PROPOSED TECHNICAL SPECIFICATIONS CHANGES

SAFETY LIMIT, REACTOR CORE

CONTROL ROD AND POWER DISTRIBUTION LIMITS,

POWER AUTHORITY OF THE STATE OF NEW YORK  
INDIAN POINT 3 NUCLEAR POWER PLANT  
DOCKET NO. 50-286

INDIAN POINT UNIT 3  
Reactor Coolant Flow > 323600 GPM  
24 Percent Tube Plugging

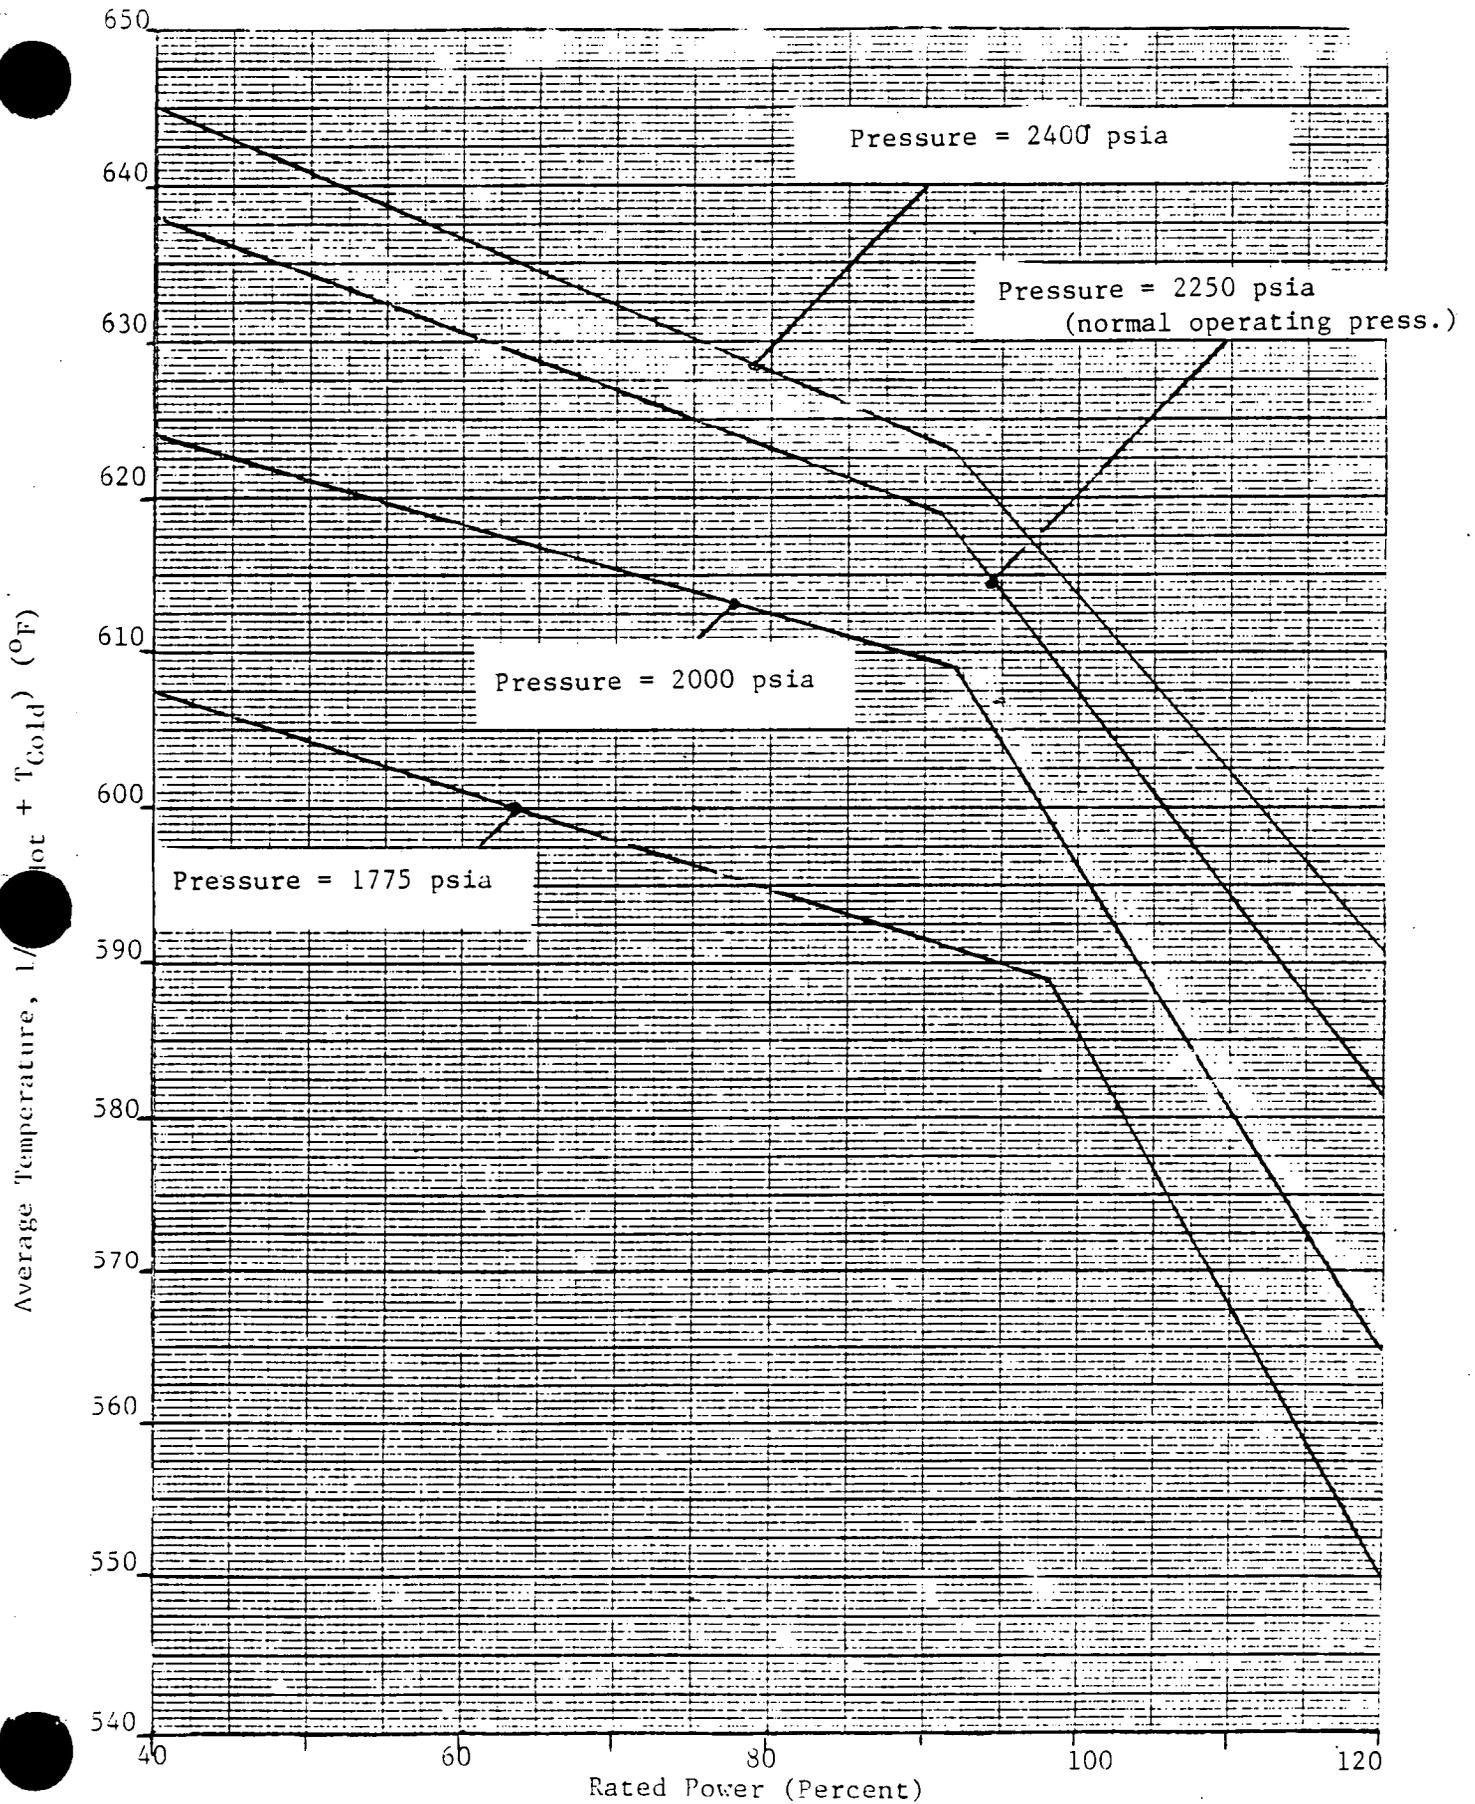
The combination of thermal power level, coolant pressure, and coolant temperature shall not exceed the limits shown in Figure 2.1-1 for four-loop operation. The safety limit is exceeded if the point defined by the combination of Reactor Coolant System average temperature and power level ~~is at any time above the appropriate pressure line.~~

The curves of Figure 2.1-1 represent the loci of points of thermal power, coolant system pressure and average temperature for which the DNBR is no less than 1.30. The area where clad integrity is assured is below these lines.

The calculation of these limits includes an  $F_{\Delta H}^N$  of 1.55, DNB penalties for increased pellet eccentricity, local power spikes, 8% uncertainty in  $F_{\Delta H}^N$ , up to 24% steam generator tube plugging, and a reference cosine with a peak of 1.55 for axial power shape.<sup>(3)</sup>

Figure 2.1-1 includes an allowance for an increase in the enthalpy rise hot channel factor at reduced power based on the expression:
